FIELD OBSERVATION REPORT

Report No. 26	Page 1 of 2
Project:	Oceans West One Condominium	Inspection For:	Building Repair and WP Project
Day/Date:	Monday, August 29, 2022	Job No.	20-1153
Location:	1 Oceans West Blvd. DBS, FL 32118	Engineer:	Christopher B. Longman, P.E.
Contractor:	SPEC Contractor Services	Project Foreman:	Alberto
Subcontractor:	None	Inspector:	Christopher B. Longman, P.E./ Andrew Holland
Weather:	82 Degrees @ 8:30 A.M.	Overcast	Light Breeze 50% Chance of Rain
Workforce Total:	14		
Activities:	Punch-out 05 stack window drop, Identify damage 02/03 balcony stack

Photograph #1: Typical balcony knee wall designated to open drain pathway

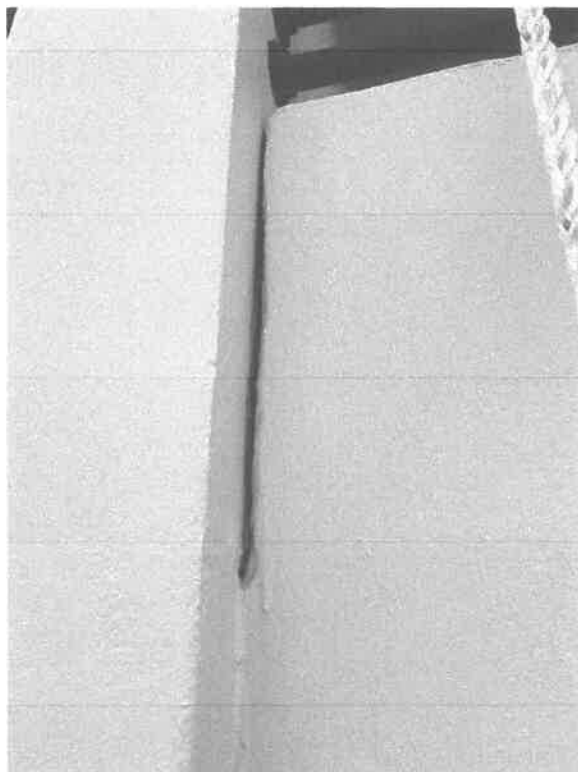
UEC visited each balcony on the 02/03 unit stack to identify stucco and concrete damage (see photo 1 and 2). The slabs, walls and columns were acoustically sounded and visually inspected. Damaged areas were marked with orange paint for excavation. There was nearly no slab damage. A small amount of spalling was identified on the walls and columns. The drain slot between the knee wall and building wall was requested to be opened to improve draining at many balconies.
